Case Number ABP – 321522-24
Scart Mountain Grid Connection
Response to Submissions Report

Document Control Sheet	
Document Reference	Scart Mountain Grid Connection Response to Submissions Report
Client:	FuturEnergy Scart Mountain Designated Activity Company Limited
Project Reference	11303

Figure 1 Updated version of Figure 3-5 in Chapter 3 of the Submitted EIAR (Consideration of Alternatives) to provide clarity on the alternative routes being assessed. Title: Alternatives to the proposed Grid Connection Route

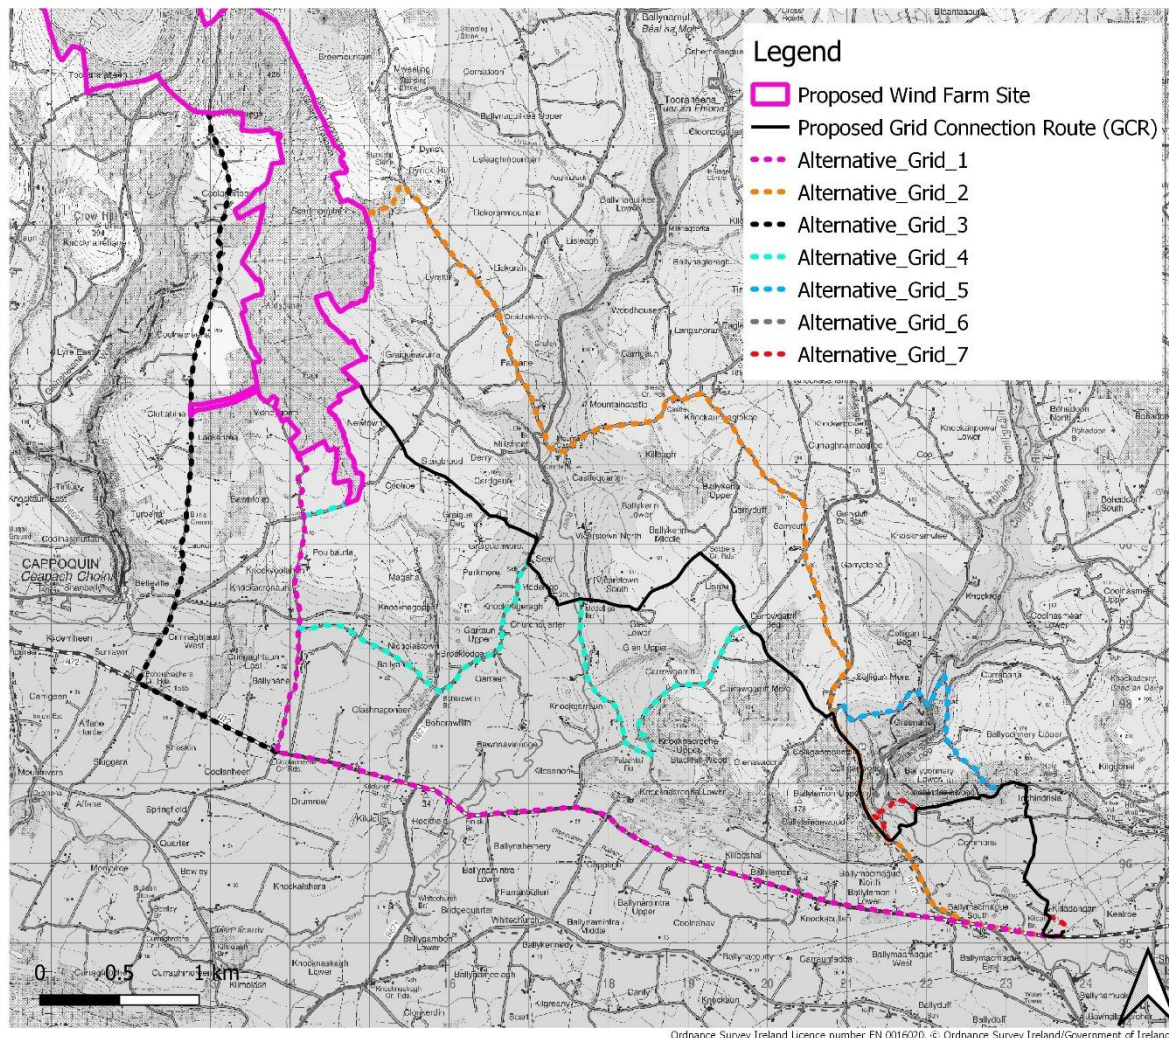
- Alternative grid connection routes mostly via the N72 (see black and pink in Figure 1 below)
- Alternative grid connection routes via local/regional roads from the eastern side of the proposed wind farm site (see orange in Figure 1 below)
- Alternative grid connection routes – short sections (see light blue, grey and dashed red in Figure 1 below)
- Alternative grid connection routes – (see turquoise in Figure 2-1 below)

It should be noted that Figure 3-5 was incorrectly labelled as Figure 3-4 in the EIAR due to a typographical error, and the routes did not all display clearly in the map. They are shown more clearly in Figure 1 below. The findings of the assessment however were unaffected by this issue and they remain valid. The proposed grid connection route is the most appropriate option for the route.

The Applicant confirms that alternative routing options were considered as part of the design process, with the selected route representing the most feasible solution when environmental, technical, land use, and planning constraints are taken into account. Routing within existing road corridors minimises impacts on private land, habitats, and landscape character.

The selection of the GCR and connection point is described in detail in the submitted EIAR. In particular, Section 3.3.3.3 (Chapter 3) outlines the alternatives considered and the rationale for the chosen route, including engineering feasibility, environmental constraints, land use considerations, and infrastructure interfaces.

Figure 2 Excerpt from the Current Waterford City and County Development Plan 2022-2028 map viewer showing landscape sensitivity classifications in relation to the proposed project

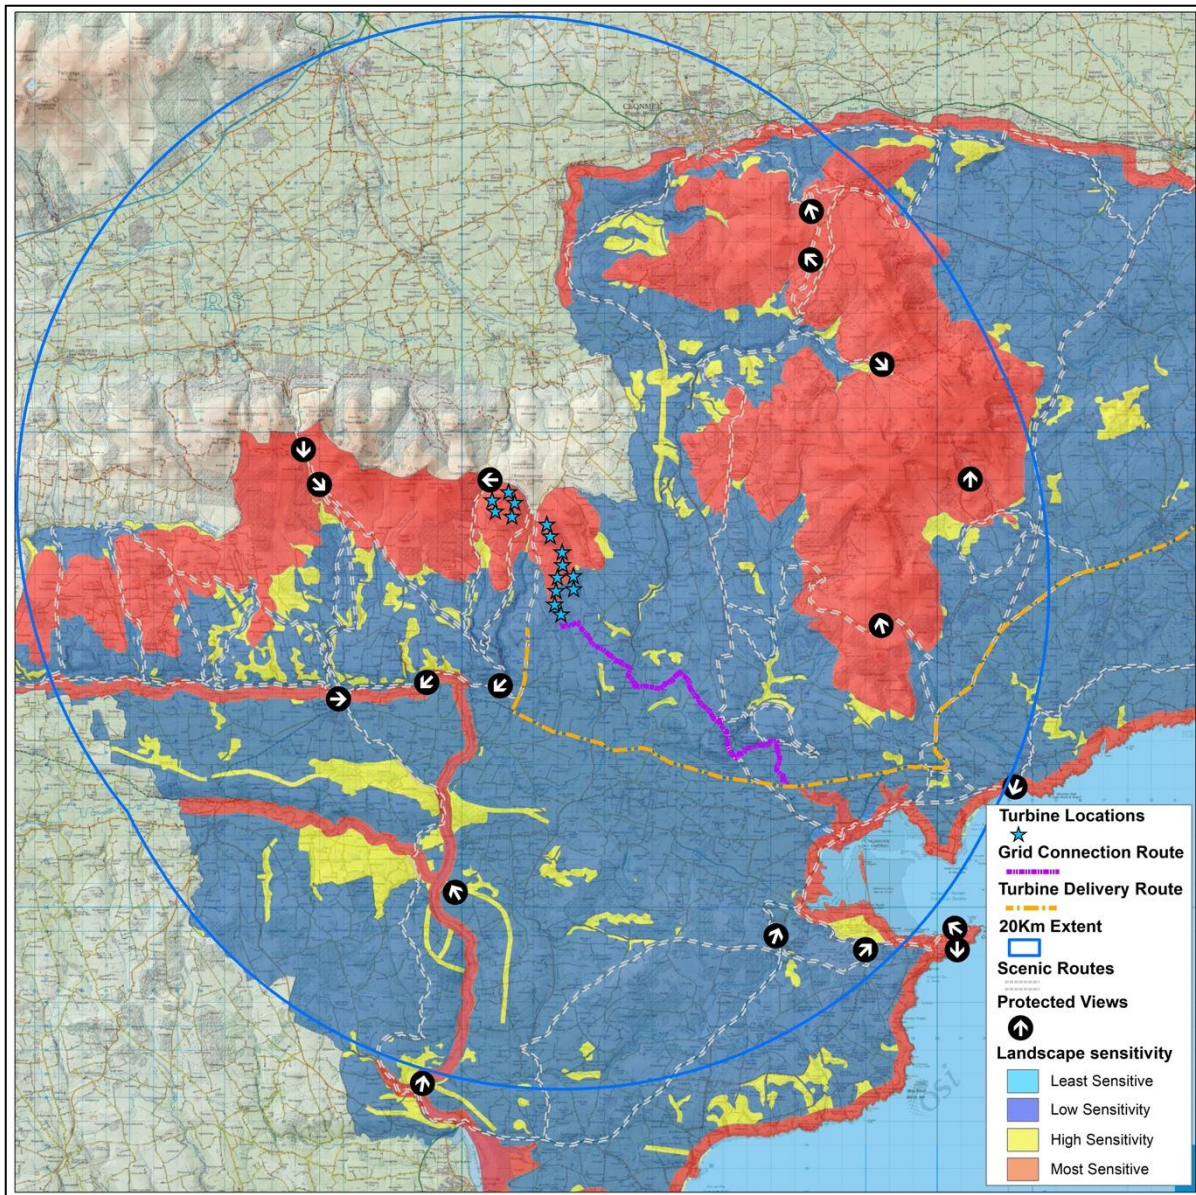
The submitted LVIA fully recognises the ‘most sensitive’ landscape classification identified in the Landscape Policy, Context and Designations section of the submitted report, which is illustrated on Figure 2 below. However, it is important to note that the proposed grid connection, is located outside of this designation and instead lies within an area classified as having ‘Low’ landscape sensitivity. This ‘low’ sensitivity classification is defined in Appendix 8 of the Waterford City and County Development Plan 2022–2028 as areas that “*have the potential to absorb a wide range of new developments, subject to normal planning and development control procedures.*”

While the designations outlined in the current County Development Plan are noted, in accordance with the guidance set out in the Guidelines for Landscape and Visual Impact Assessment (GLVIA3, 2013), the submitted LVIA also undertakes an independent assessment of landscape sensitivity (see Subsection 13.6.1 of the report). Overall, the sensitivity of the central study area (up to 5km from the separately proposed turbines associated with this project) was assessed as Medium, with some localised areas of higher sensitivity. Whilst the

With specific reference to the grid connection facilities, these are located within the southern extent of both the central and wider study areas, which are considered among the more robust and typical parts of the surrounding landscape, reinforced by the ‘low’ landscape sensitivity classification outlined in the current Waterford County Development Plan (refer to Figure 2 below). In this part of the study area, the predominant land use is pastoral farmland, and the landforms are generally less distinctive than those found within the eastern, northern and western extents of the wider study area. Overall, the grid connection route is primarily influenced by robust, working rural landscapes that are not considered to be particularly rare or distinctive. This characterisation is consistent with the ‘Low’ sensitivity classification assigned to this area within the current Waterford County Development Plan.

Figure 2-3 Excerpt from Appendix 2 of the current Renewable Energy Strategy showing wind energy classification areas in relation to the proposed turbines and grid connection

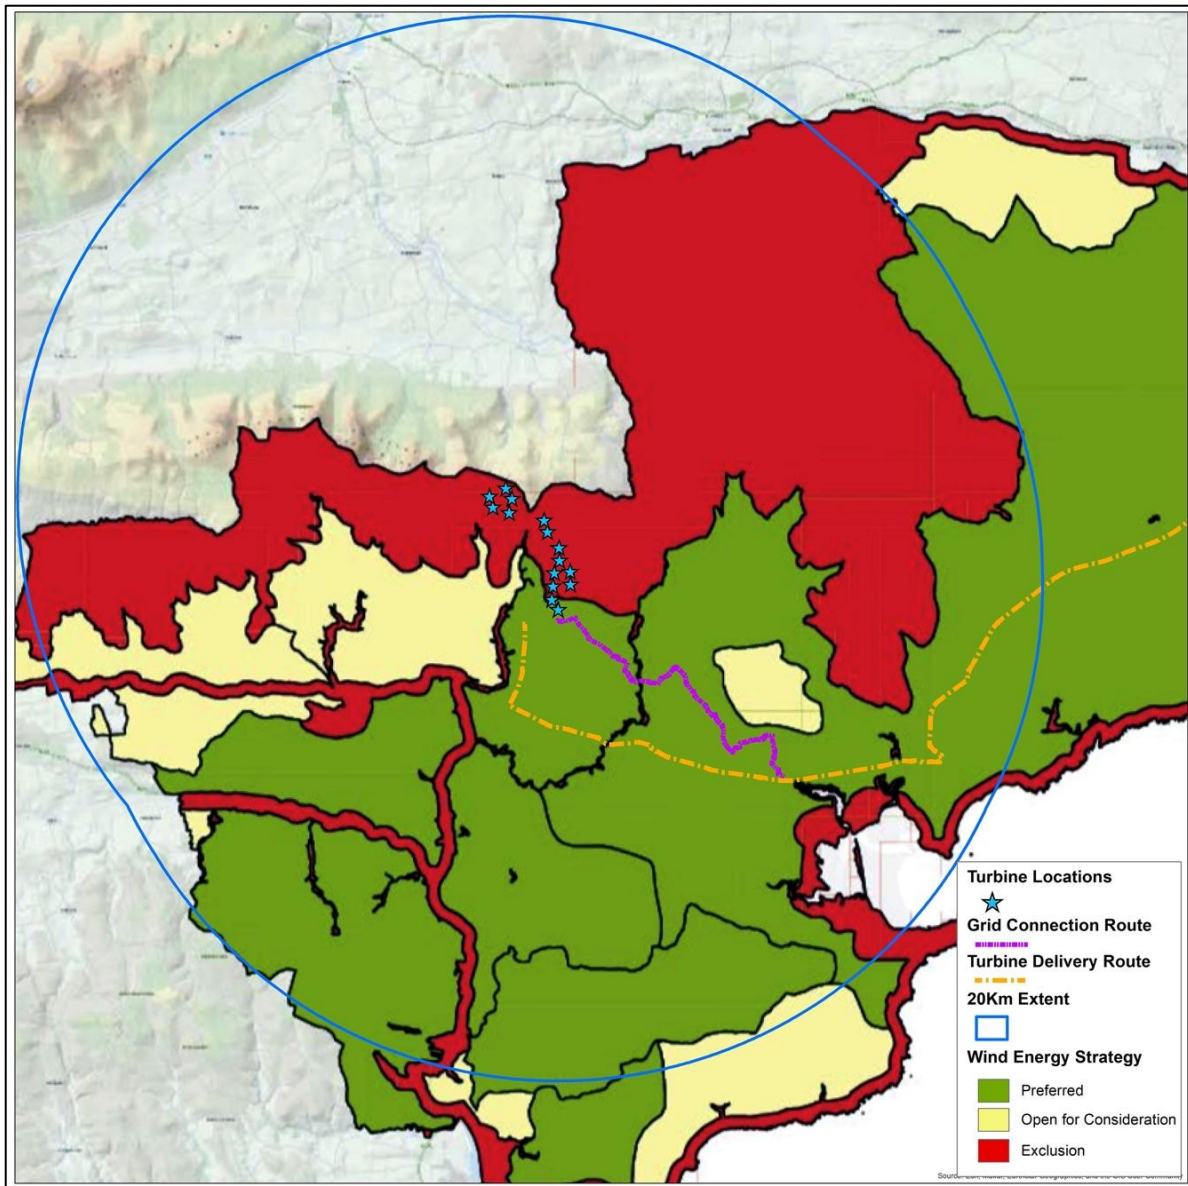
2.2.2 Perceived location of the proposed Grid Connection facilities within an ‘exclusion’ wind energy zoning

In a similar context to the landscape sensitivity zoning discussed above, it is also important to note (as per Subsection 13.3.2.2 of the submitted LVIA and in Figure 2-3 below), the proposed grid connection elements of the project, are located within a ‘preferred’ wind energy zoning designation.

Overall, it is considered that these lands can well accommodate the proposed grid connection infrastructure as indicated by the ‘preferred’ wind energy classification and aforementioned ‘low’ landscape sensitivity classification.

Figure 4 Reproduction of submitted EIAR Figure 8-4 for information purposes – see Figure 8-4 in Chapter 8 of EIAR for full details

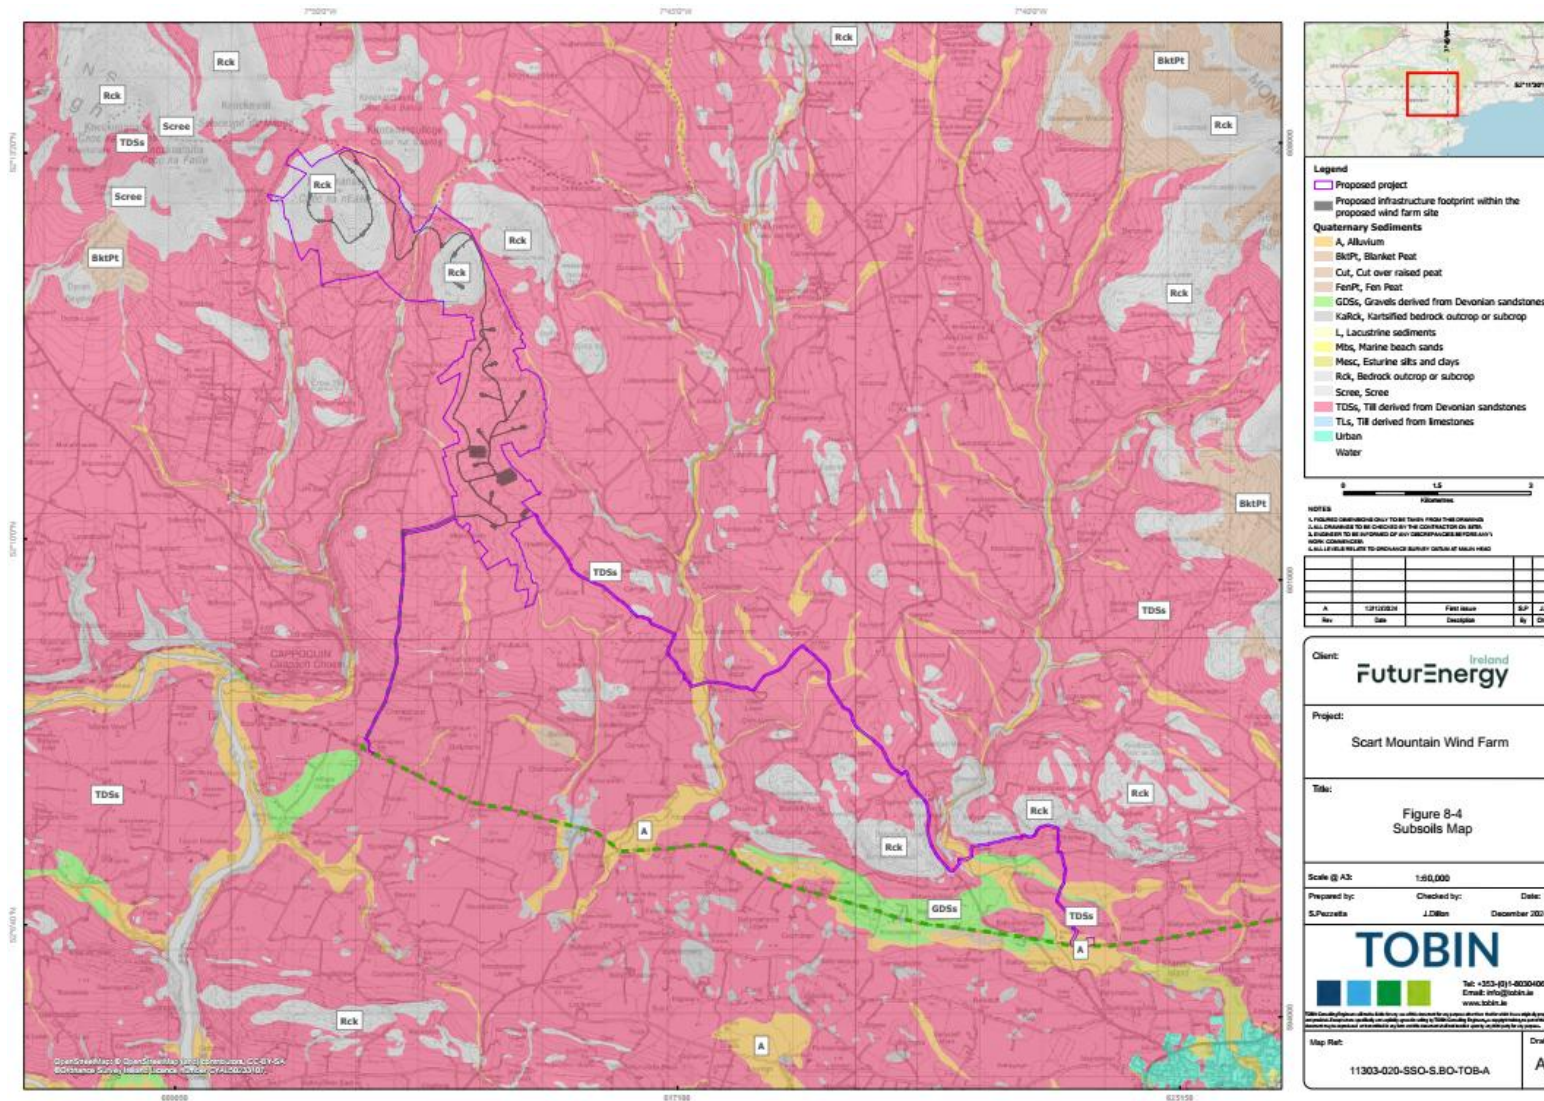
A concern was raised relating to soil stability and peat along the proposed GCR. The proposed GCR is located primarily in public road corridors where there are no known peat soils. As shown in Figure 8-4 (Chapter 8) of the submitted EIAR (reproduced below for convenience of the reader), there are no mapped (by GSI) peat soils located along the GCR and no peat was identified during site visits. Therefore, the concerns raised relating to peat and soil stability are not applicable to the proposed GCR. Figure 8-4 is included below.
